HISTORIC AND DESIGN REVIEW COMMISSION June 19, 2019

HDRC CASE NO: 2019-323 ADDRESS: 412 HAYS ST

TYPE OF WORK: Construction of a rear accessory structure, fencing, site work

1 ARCHITECTURAL SITE PLAN

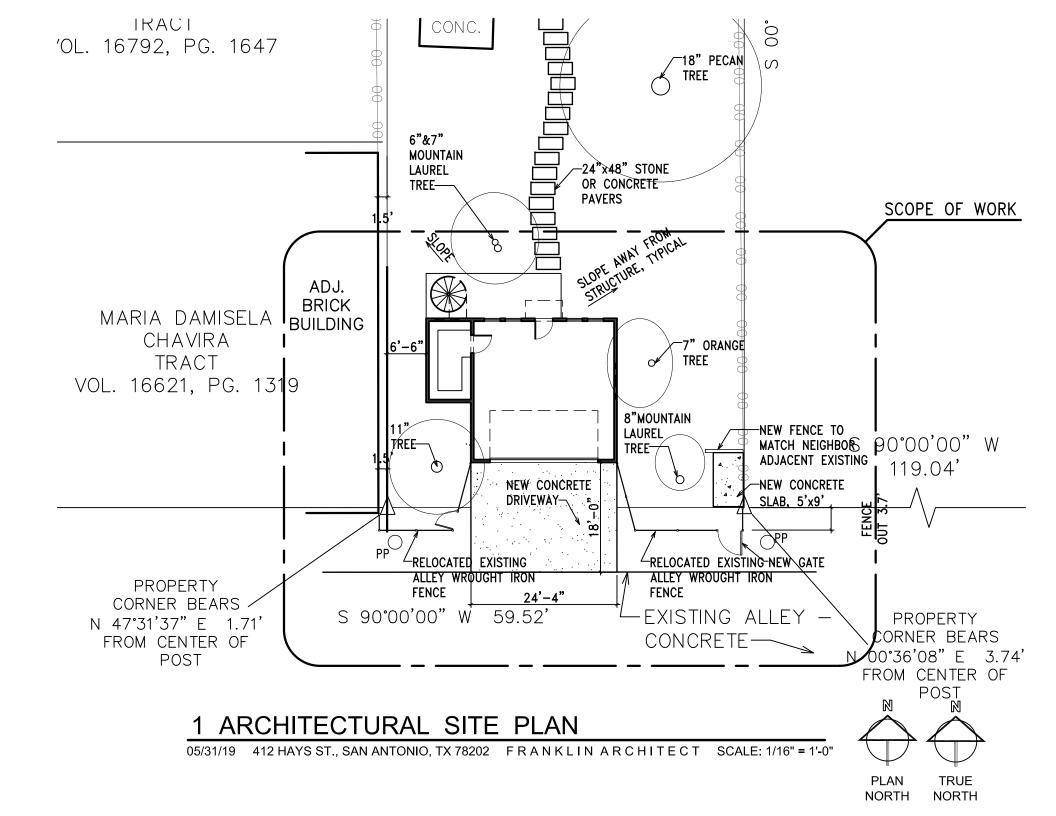
- i. SITE WORK The applicant has proposed to install a driveway that features a width of 24' 4". Existing driveways and aprons on Armadillo Alley feature widths of approximately eight to fourteen feet in width. Staff finds the proposed driveway width to be inconsistent with the Guidelines, which notes that existing driveway widths and profiles should be matched. Staff finds that the applicant should explore ways to reduce the proposed driveway's width, or incorporate alternative materials as to not feature more than ten (10) feet of continuous concrete paving.

- ii. That the applicant should explore ways to reduce the proposed driveway's width, or incorporate alternative materials as to not feature more than ten (10) feet of continuous concrete paving.

1 DOOR & WINDOW SCHEDULE

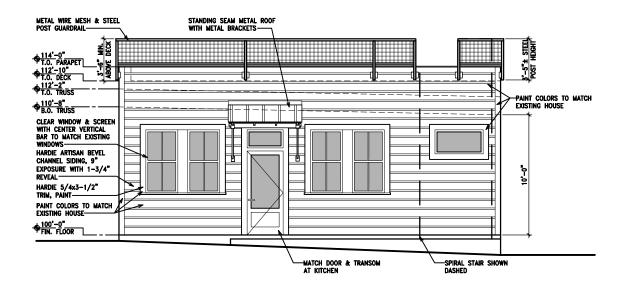
- h. WINDOW MATERIALS The applicant has proposed fiberglass windows. Staff finds that a double-hung, one-over-one wood windows or aluminum-clad wood windows be used.. Meeting rails must be no taller than 1.25" and stiles no wider than 2.25". White manufacturer's color is not allowed, and color selection must be presented to staff. There should be a minimum of two inches in depth between the front face of the window trim and the front face of the top window sash. This must be accomplished by recessing the window sufficiently within the opening or with the installation of additional window trim to add thickness. Window trim must feature traditional dimensions and architecturally appropriate sill detail. Window track components must be painted to match the window trim or concealed by a wood window screen set within the opening.

- i. That the applicant install wood or aluminum clad wood windows that feature meeting rails that are no taller than 1.25" and stiles no wider than 2.25". White manufacturer's color is not allowed, and color selection must be presented to staff. There should be a minimum of two inches in depth between the front face of the window trim and the front face of the top window sash. This must be accomplished by recessing the window sufficiently within the opening or with the installation of additional window trim to add thickness. Window trim must feature traditional dimensions and architecturally appropriate sill detail. Window track components must be painted to match the window trim or concealed by a wood window screen set within the opening.
